From: Marcus and Janet Wyton
Sent: 6 Jul 2018 05:23:25 +1000
To: Contact Us
Subject: Objection to DA0317/2018 Advertised Plans for Proposed New Residence 38A Hill St West Launceston

**Written Representation: Objection to DA0317/2018
Advertised Plans for Proposed New Residence 38A Hill St West Launceston**

OBJECTION - PLANNING APPLICATION DA0317/2018 38A HILL STREET

SCALE: N/A	DRAWING NO: P06
Sheet dimensions: (A3)	DRAWN BY: ME
Material: Aluminum plate	SHEET NO.: 6 of 8

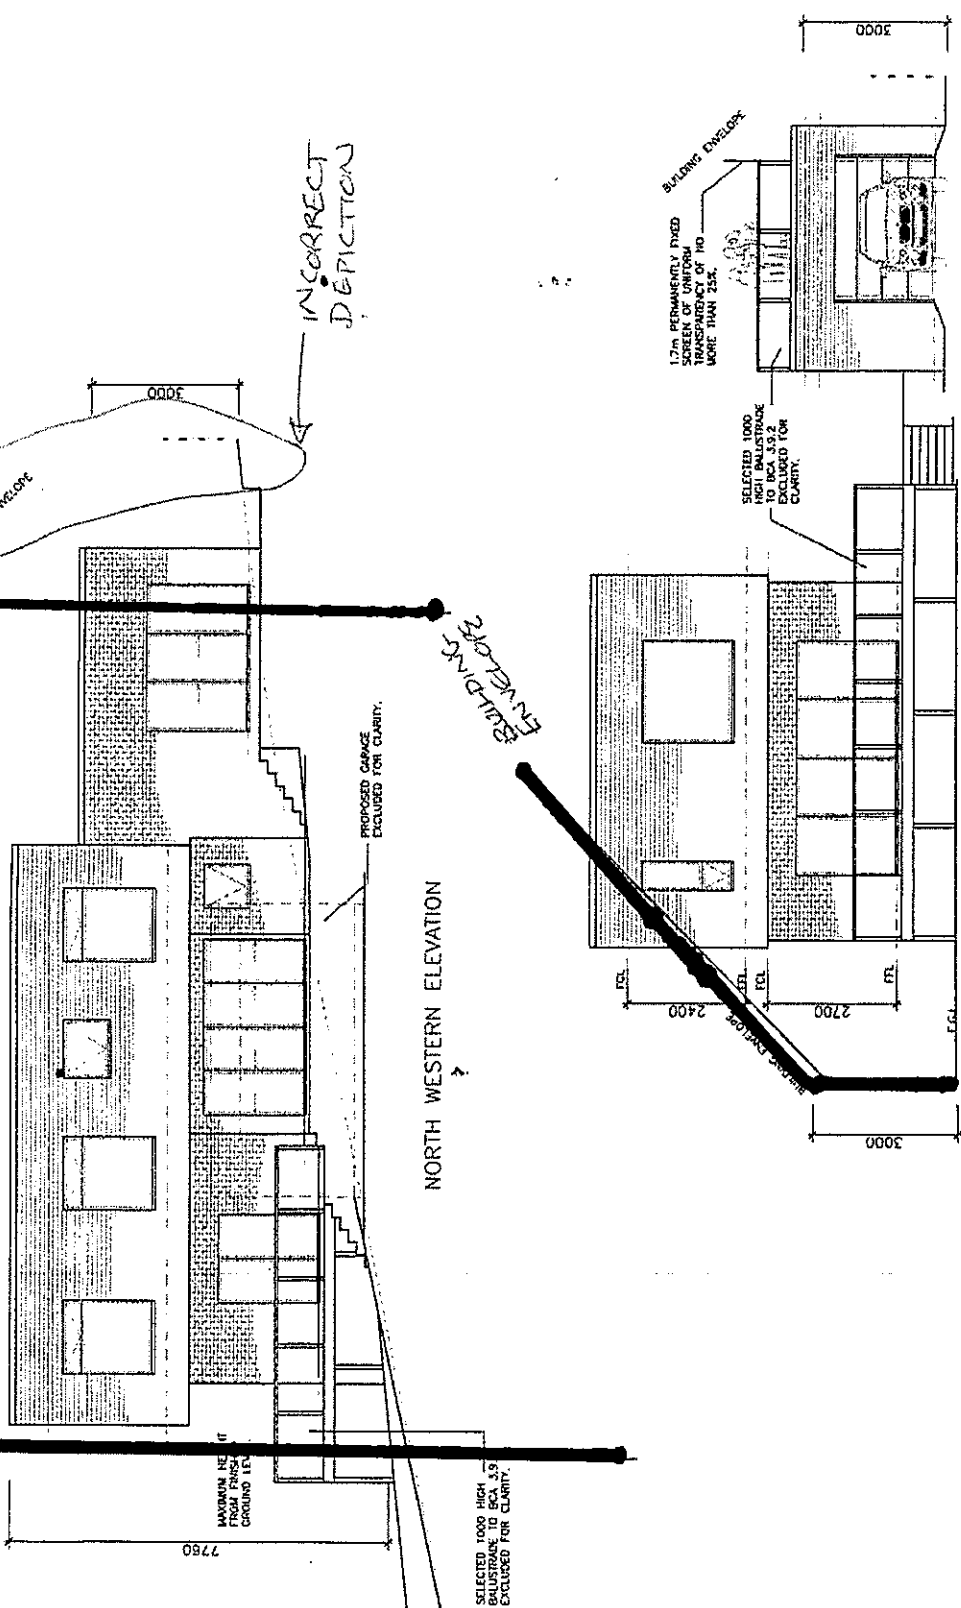
- PO6 is misleading in suggesting that the front and rear of the proposed building sit within the building envelope required by the planning scheme. We have amended the drawing (attached and marked 'Annexure A') to show that, in fact, the rear of the building extends beyond the required building envelope.
- Drawing number PO5 (North Western Elevation) misleadingly suggests that the rear of the proposed building sits well within the building envelope. We have amended the drawing (attached and marked 'Annexure B') to show how far the proposed building sits outside of the building envelope.

- The height of the proposed building exceeds the building envelope as shown on Annexure-B;
- The rear of the proposed building exceeds the building envelope as shown on Annexure-B
- The front of the proposed building exceeds the required setback as shown on Annexure-C

ANNEXURE B

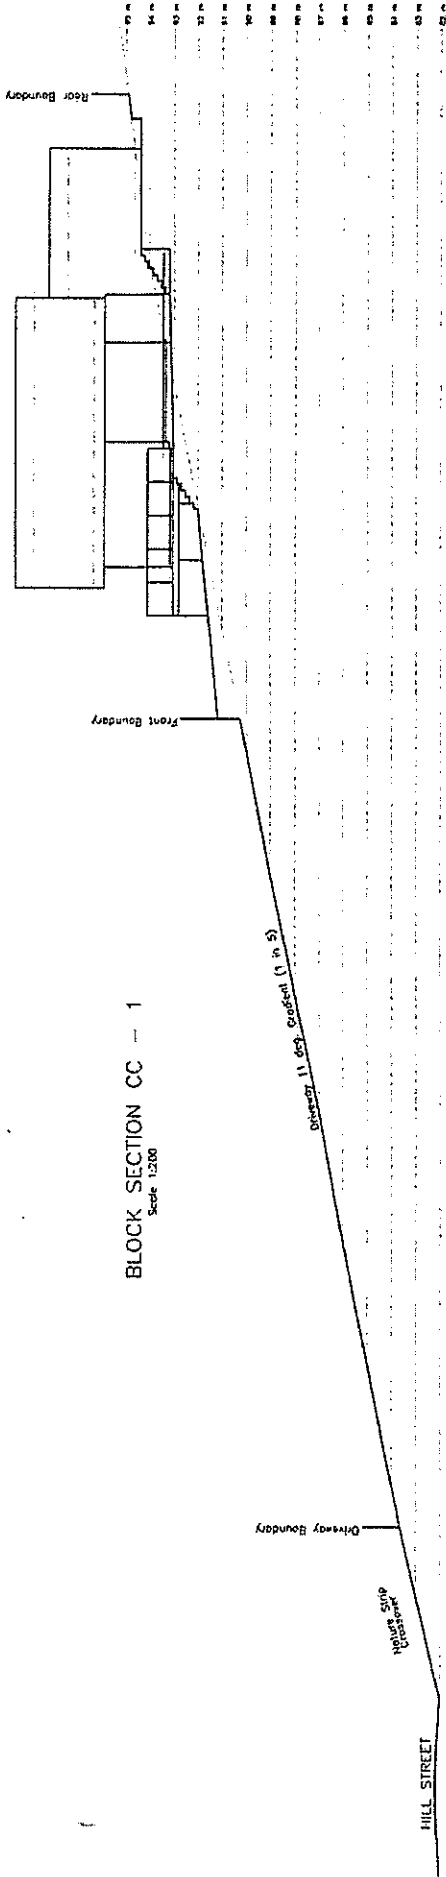
- Drawing number PO5 (north Western Elevation) is unclear as to whether or not the front of the building sits within the building envelope. The drawing should show where the building envelope sits in comparison to the front of the proposed building. We have amended the drawing (attached and marked 'Annexure B') to show that the front of the proposed building may not fit within the building envelope. It is difficult to be accurate about this without proper drawings showing the scale of the drawings.

- Drawings number PO1 & PO5 (North Western Elevation) only show the proposed garage as a dotted line, hiding the visual bulk of the proposed building. It is stated that the "proposed garage is excluded for clarity" but there are no plans that adequately show the visual bulk and impact of this proposed garage which is 3 metres high and only 1 metres off the neighbour's boundary.

- The proposed garage includes a party deck that looks directly into the neighbour's property and their main living areas. Drawing number PO5 (North Eastern Elevation) suggests that the 1.7m high "permanently fixed screen" between the party deck and the neighbouring land is high enough to shield the neighbours from the invasion of privacy. This is misleading, as the human figures used are dwarfish. The average height of Australian men is 1.78m. A man of average height, in shoes, will be able to see over this screen into the neighbour's land and private living area. This is also true of most women (taking account of the average height of women in average size heels).

ANNEXURE "C"

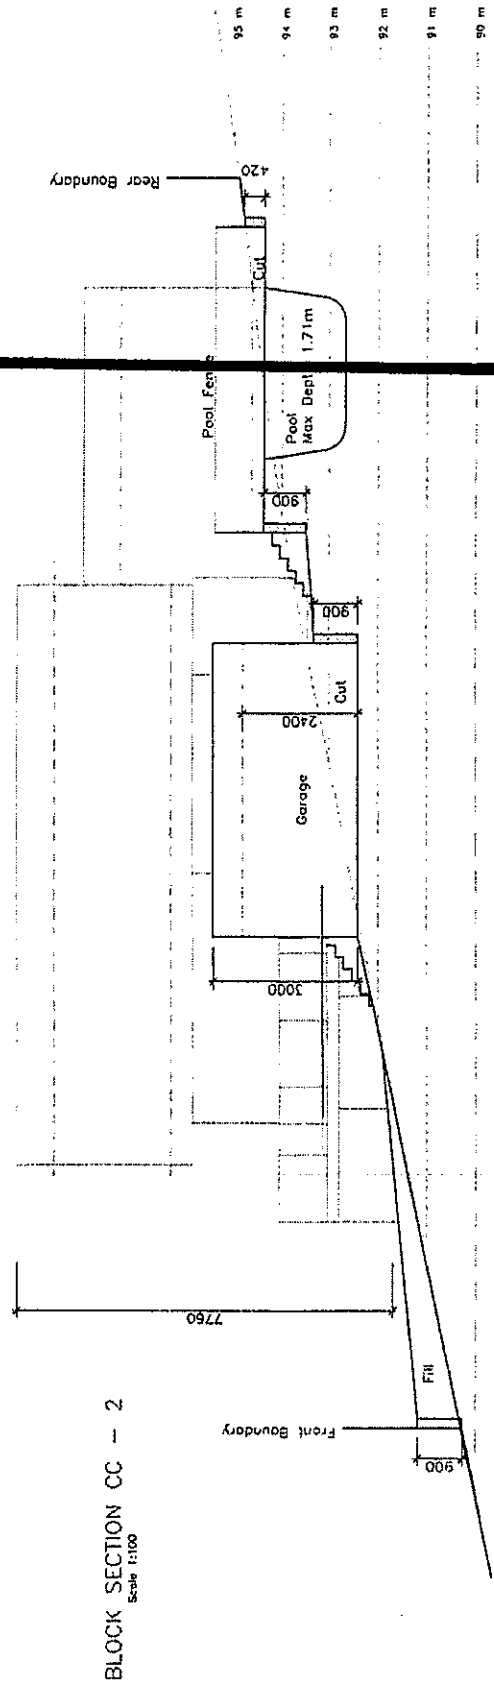
- We attach (and mark "Annexure C") submitted drawing PO8 with our amendments which show a more accurate reflection of building envelope.
